**ADDENDUM 001  
REQUEST FOR Quote**

**, D611-148-RW Signal Replacement and Relocation**

## REVISED SCOPE OF WORK D611-148-RW

Scope of work: **Part One( revised)**

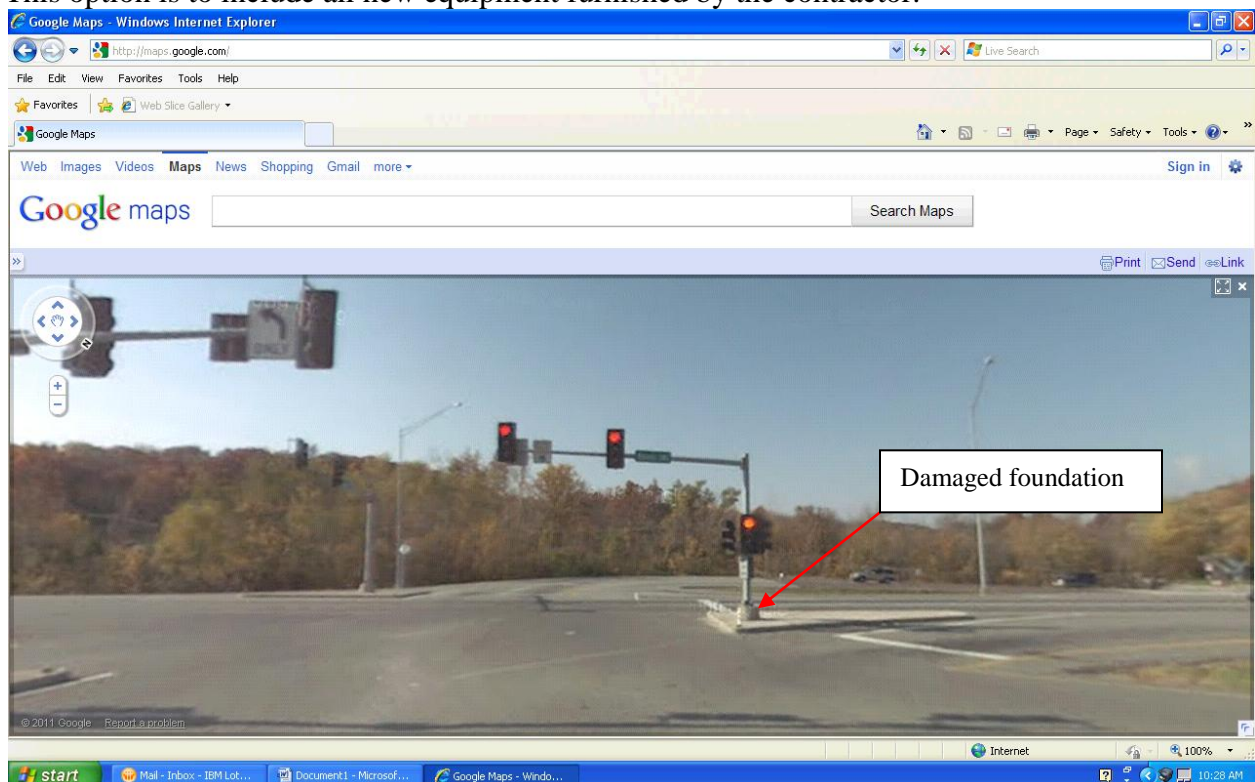
Location: Rte 141 @ Romaine creek/Hilltop Dr

Description: removal and relocation of signal base foundation and installation of new signal upright, arm and signal indications.

At the intersection of route 141 @ Romaine creek/Hilltop drive, the existing damaged Type 'A' concrete foundation is to be completely removed flush and replaced within 10 ft of existing pull box with a new Type 'A' concrete foundation as per MoDOT specifications. Also to include the installation of an upright, 35 ft arm, (5) 3-section signal heads as shown (3 with left turn green arrows), mounting hardware and (5) cable conductors, making all proper connections in signal heads to terminal box to signal control cabinet, using MoDOT approved equipment while meeting MoDOT's standards and specifications. The installation of 10 ft new conduit (1 1/4 inch dia.) system from Type 'A' concrete foundation to existing pull box, ensuring clear path to pull new cable thru existing conduit system. Also to include the installation of (5) new cable conductors (16 awg/ 7c) to run from new signal head terminal box thru pull boxes back to signal control cabinet, approximately 240 ft in length x 5, making all proper connections and terminations, so as to return the signal network system to its original operations.

This option is to include all new equipment furnished by the contractor.

The contractor shall be responsible for all utility locates and work zone traffic management in accordance to all portions of MoDOT standards and specifications.

## Part 2 (revised)

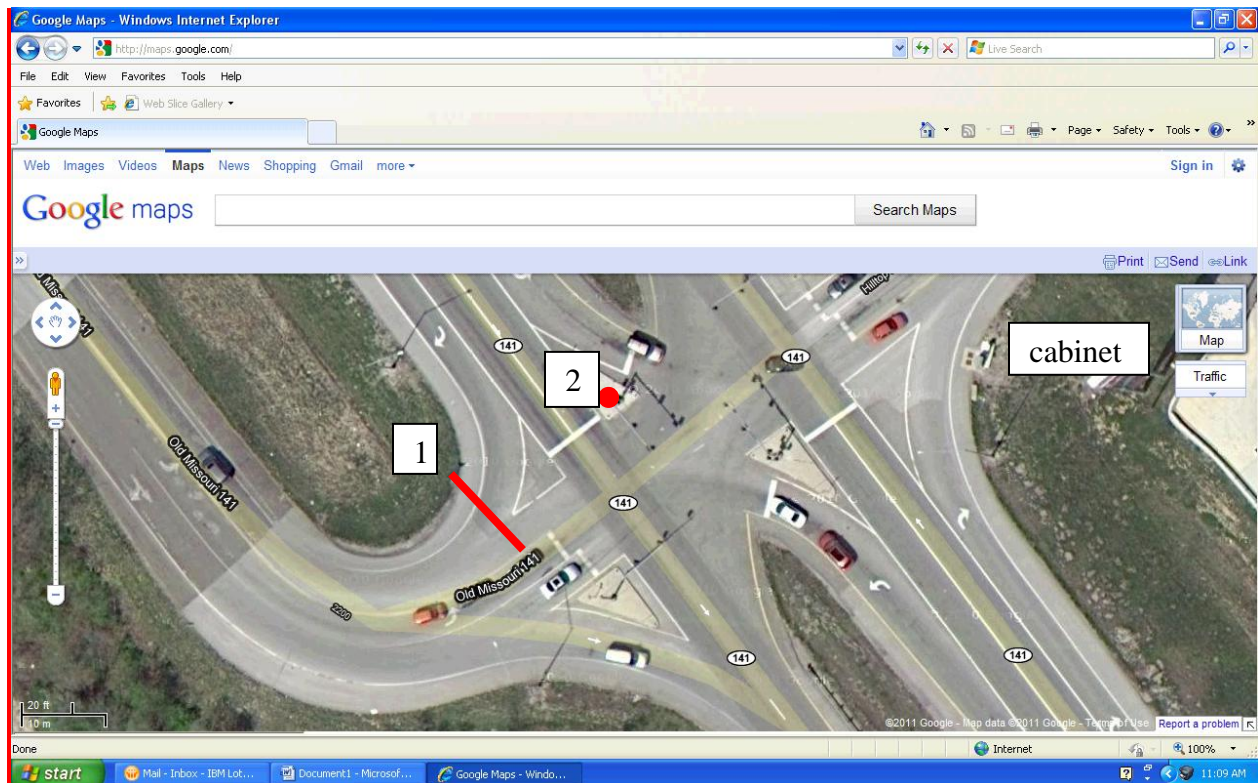
Location: Rte 141 @ Romaine creek/ Hilltop Dr

Description: removal and relocation of signal base foundation and installation of new signal upright, arm, pedestal and signal indications

At the intersection of route 141 @ Romaine creek/Hilltop drive, the existing damaged Type 'A' concrete foundation is to be completely removed flush and replaced within 10 ft of existing to accommodate a Type 'C' pedestal mount signal base, 15 ft post, (2) 3-section signal heads, (2) 16awg/7c cables and 1 ¼ inch dia. conduit to existing pull box making proper connections as required. At the same location to install a new Type 'A' concrete foundation on the southwest corner to install new upright, 40 ft arm, (3) 3-section signal heads, mounting hardware, 85 ft - 1 ¼ inch dia. conduit, (3) cable conductors making all proper connections in signal heads, terminal box to signal control cabinet, using MoDOT approved equipment while meeting MoDOT's standards and specifications. To install approximately 85 ft of new 1 ¼ inch dia. conduit system and required preformed Class 2 pull box from this location, so as to intercept existing conduit system in the center island to gain access back to signal control cabinet.

Also to include the installation of (5) new cable conductors (16awg/7c) to run (2 @ 180 ft / 3 @ 285 ft) from signal head indications, terminal box to signal control cabinet. All connections and terminations shall be required to return the signal network system to its original operation.

This option is to include all new equipment furnished by the contractor.
